NOTICE OF VIOLATION

On July 25, 2024, Energy Safety conducted an inspection of Southern California Edison Company's WMP initiatives in the vicinity of the city of Menifee, California. The inspection report is enclosed herewith. Energy Safety found the following violation:

INSPECTION REPORT

Exhibit A: Photo Log Structure ID: 4791537E Violation 1

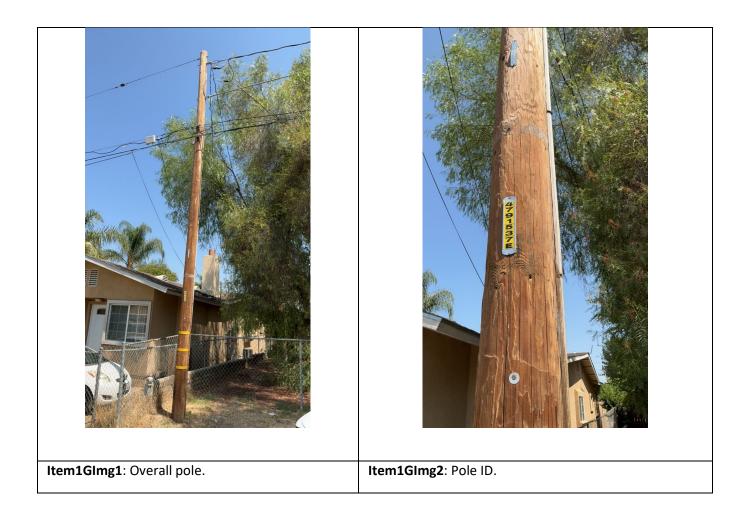
On Pole ID 4791537E, Grid Hardening ID TD2090512-4791537E, at 23760 Elsinore Ln, Menifee, CA, 92587, USA, 33.708657937469816, -117.24481636216132, the inspector observed bare conductor where covered conductor installation was reported as installed by Southern California Edison Company. The inspector's observation is documented in Violation 1 photographs, which are attachments to this report. Photo numbers Item1GImg1, Item1GImg2, and Item1IA1Img1 depict a secondary distribution pole where covered conductor installation was reported as completed.

- 1. Southern California Edison Company reported that WMP initiative 8.1.2.1.1 Covered Conductor Installation was completed at this location.
- 2. Covered conductor was not installed.

Energy Safety may prescribe a timeframe for resolution of a violation associated with the assigned risk category.² Within 30 days from the issuance date of this NOV, the electrical corporation must provide a response advising Energy Safety of corrective actions taken or planned to remedy the above identified violation(s) and prevent recurrence. Alternatively, the electrical corporation must advise Energy Safety that it will not correct the violation, including the reasoning or justification for inaction and all supporting documentation.³
